Technical Service Bulletin: TSB200013

New QSK60 Lube Filter

Figure 1, Filter Part Number Label

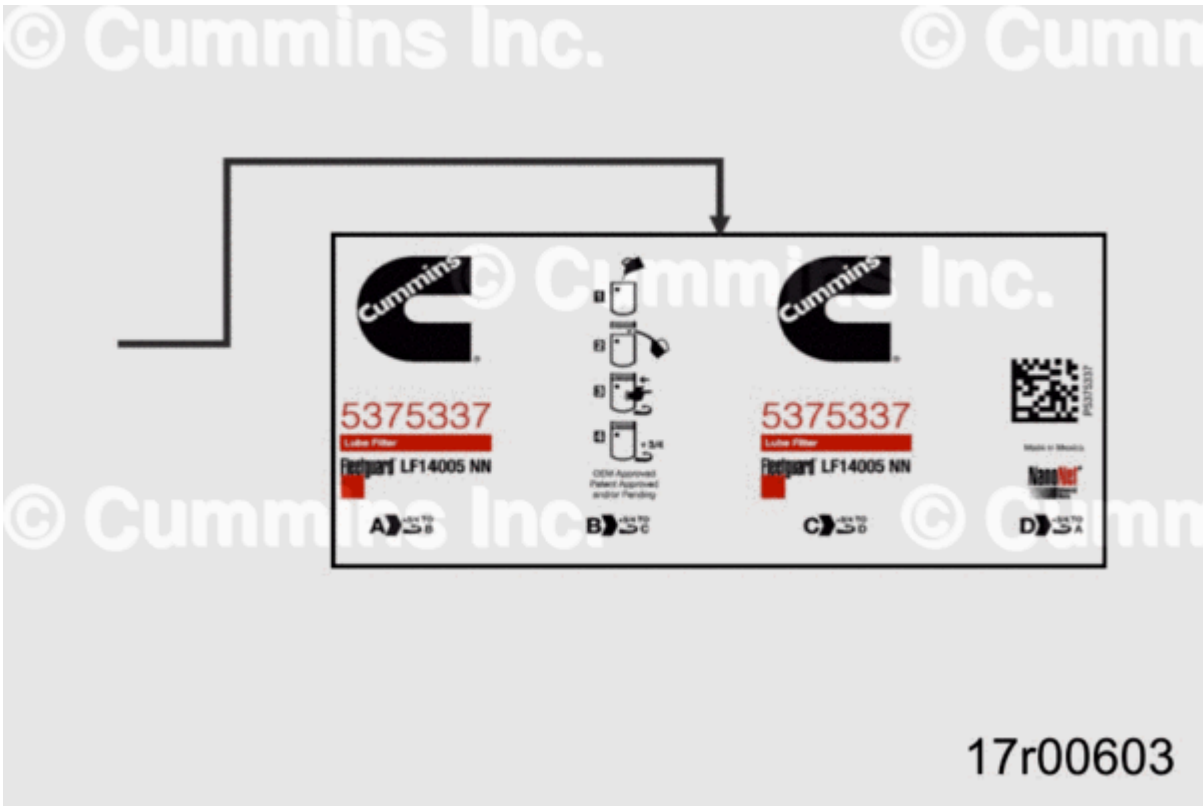
Part Identification

All lube filters will have a Cummins label clearly displaying filter part numbers.
